Report to Development Permit Panel

File: DP 15-718109

Re: **Application by Douglas L. Massie, Architect for a Development Permit at
6020 Steveston Highway**

**Annotated Excerpt from the Minutes from
Advisory Design Panel Meeting
Wednesday, July 19, 2017**

1 PROPOSED ROOF PLAN

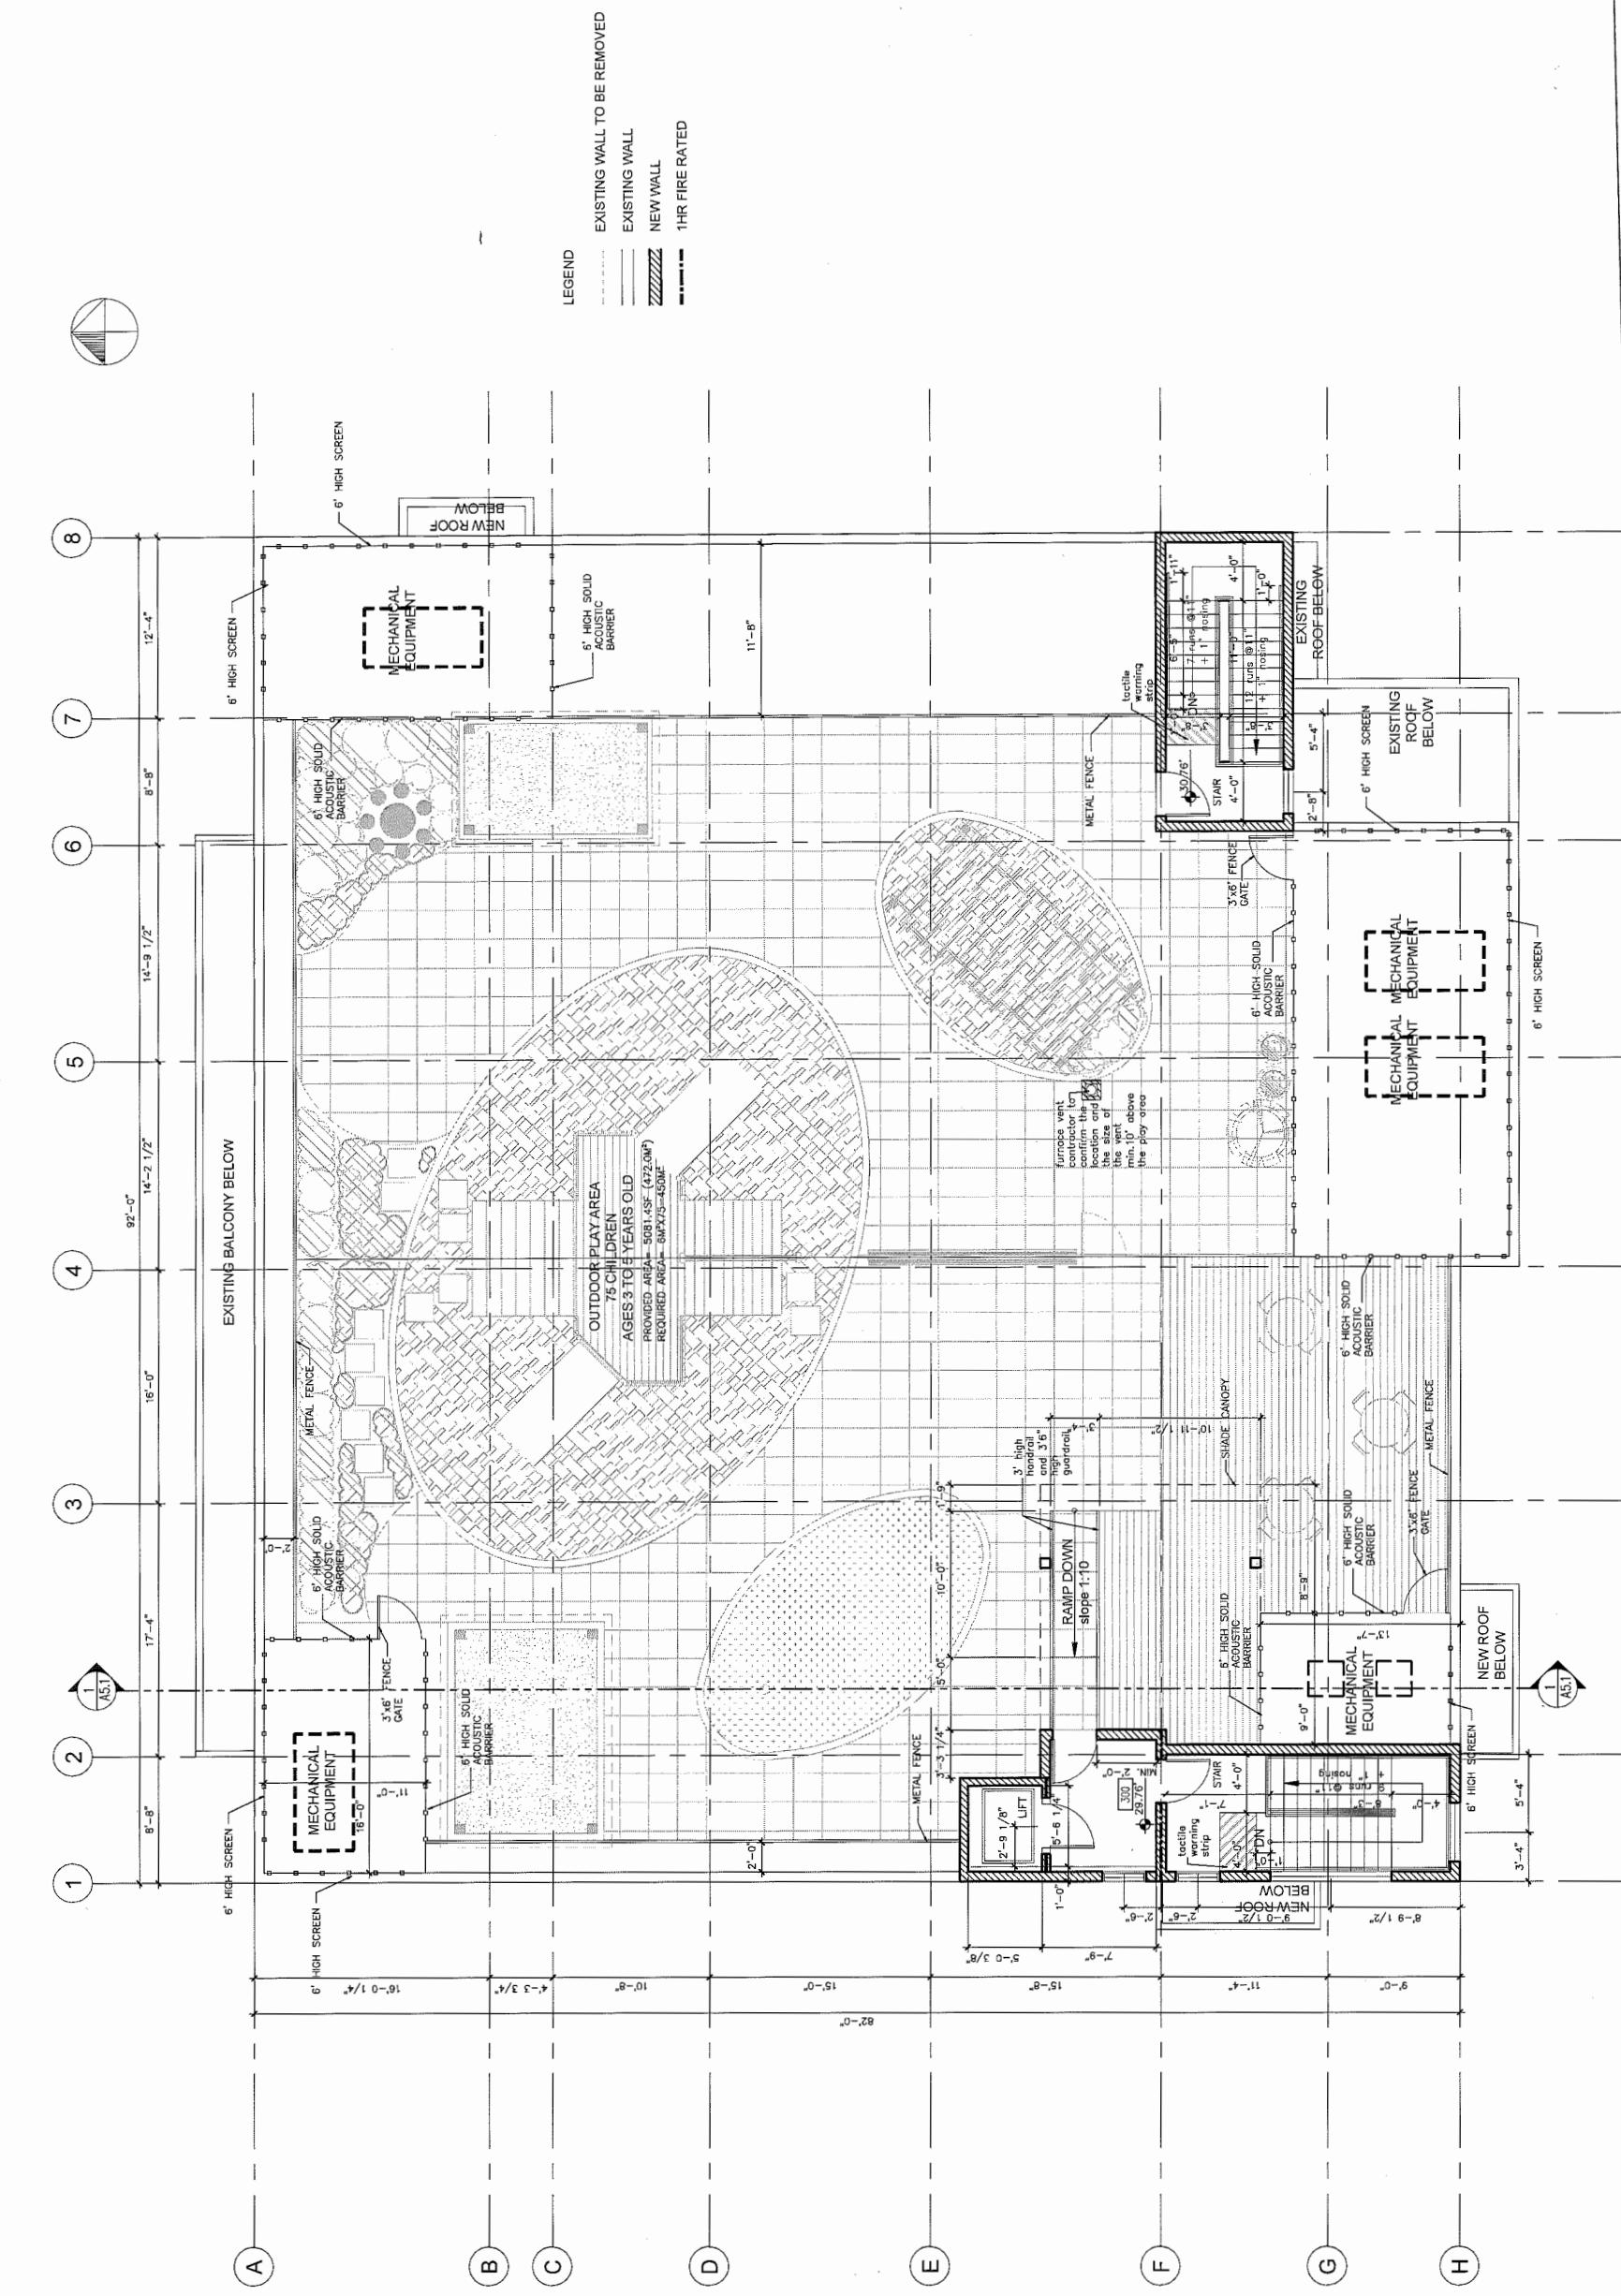
- proposed rooftop play area is accessible; lay-out is logical; consider increasing the height of the fence which provide screening for the mechanical equipment to provide more separation to the play area – **1.8 m high fencing will be used.**

- consider installing a shade canopy or seasonal options at the southeast corner of the rooftop – **Additional shade cover will be added to both rooftop play spaces. On the west side a trellis will be constructed over the artificial turf lawn space and umbrellas at the tables. On the East side an umbrella will be added to the play space adjacent the chalk boards.**

- proposed roof enclosure for mechanical units is small considering that four mechanical rooftop units (RTUs) are being proposed in addition to the existing RTUs for CRUs – **Area has been reviewed and is acceptable to project mechanical engineer.**

- consider expanding the size of the trellis feature on the rooftop and locating the posts outside the elliptical figure – ***Considered. The trellis posts are located within the Fibar and artificial Turf areas for safety purposes, as the rubber area is for running and tricycling. A trellis has been added to the artificial turf lawn space on the east side, and the width of the trellises has been extended to follow the oval shape for better shade coverage.***

- consider a lighter coloured recycled rubber tile for the rooftop playground surface to mitigate heat absorption and enhance the play experience of children – ***Alternate colours and availability will be considered during construction.***
